Why underpasses?

The case for safe, attractive and convenient
underpass crossings of Horsham's A264
Northern Bypass

Horsham District Cycling Forum

Figure 2.6: Example of At Grade Signalised Crossings Integrated into Potential A264 Junction

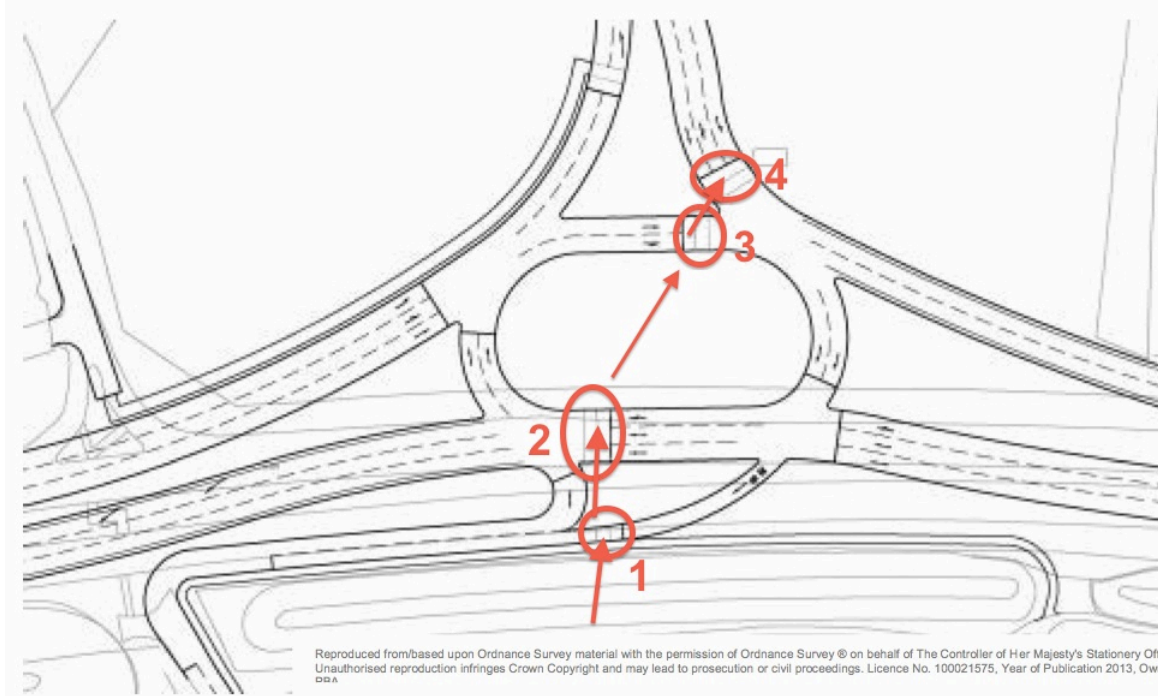
Underpasses are **more convenient**.

There is no delay - no waiting for signals to change. By contrast, the proposed roundabout designs on the A264 may require up to four separate crossings, with waits at each, just to cross the road. This is an unacceptable amount of delay.

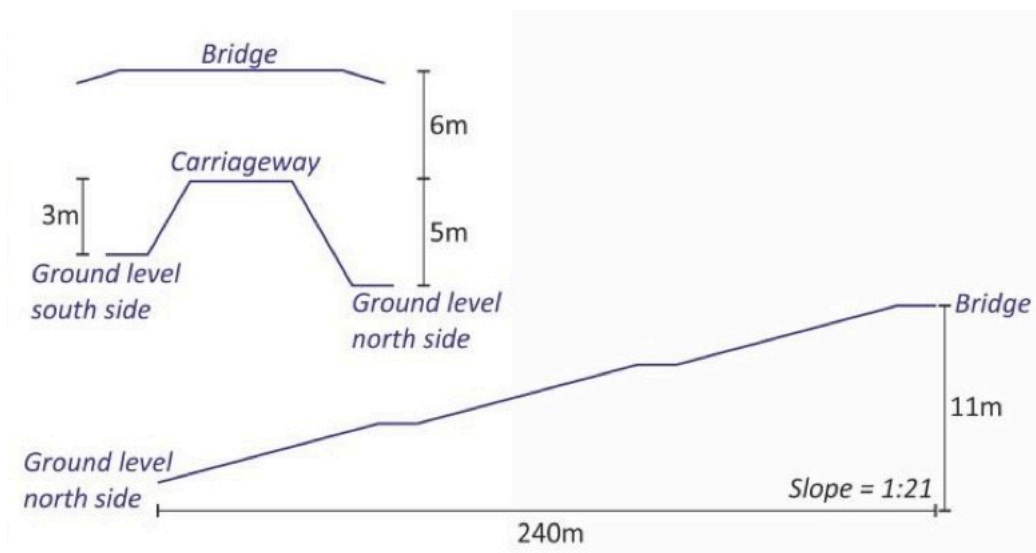
The plans for the North of Horsham development show a single bridge crossing point. Bridges are generally inferior to underpasses, for the following reasons:

This is especially true for crossings of the A264 northern bypass, which is built on an embankment, already 3-5 metres higher than the surrounding ground.

A bridge crossing of this road will require considerable height gain; an underpass crossing would be virtually flat.

The bridge has to scale 5m of embankment, plus a further 6m to a safe height above the bypass itself - a total height gain of 11m, meaning a 240m long approach ramp at around 5% slope (the absolute maximum recommended by international guidance). By contrast, paths could pass through the northern bypass virtually on the flat, at ground level.
